UNITED STATES DEPARTMENT OF COMMERCE
Patent and Trademark Office

09/418,902 10/15/99 KLEMP

Office Action Summary

DETAILED ACTION

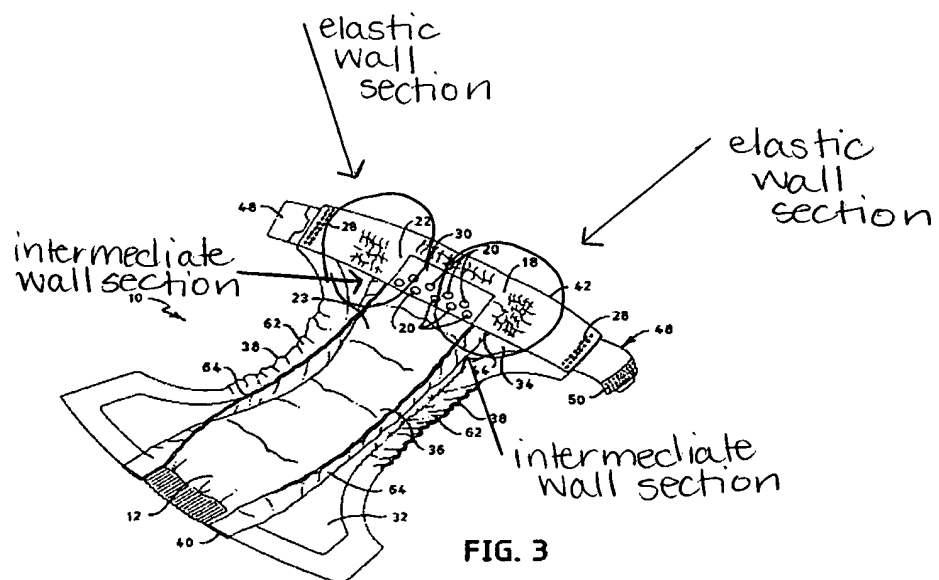
With respect to claim 1, Turner et al (hereinafter referred to as Turner), teaches a disposable absorbent article having side and end edges (10), a topsheet layer (12), a backsheet layer (14), an absorbent core (16), and at least one end strip (18, 19) as shown below:

Turner discloses the first section having generally elastic properties (col. 9, lines 42 – 43), and the second section can be understood to be substantially less elastic than the first section since the second section includes apertures (page 11 of the applicant's specification). Additionally, Turner teaches the third section being spaced away from the topsheet and core as set forth in col. 4, lines 65 – 66.

As to claim 29, see the rejection of claim 1. Turner teaches the flap to be joined to the topsheet (constituting a fixed end section) in col. 4, lines 38 – 40. Additionally, Turner discloses the section to be substantially elastic (col. 9, lines 42 – 43). The fixed end section is comparable to the second section as shown in the drawing incorporated in the rejection of claim 1. Likewise, the elastic inward section is comparable to the third section as shown in the drawing incorporated in the rejection of claim 1.

As to claim 31, see the rejection of claim 1 with the intermediate section being comparable to the second section as shown in the incorporated drawing.

With reference to claim 40, see the fixed end section is represented by the first and second sections in the drawing incorporated in the rejection of claim 1 since both sections are adhesively joined to the topsheet. This section substantially adjacent one of said end edges as seen in figure 3.
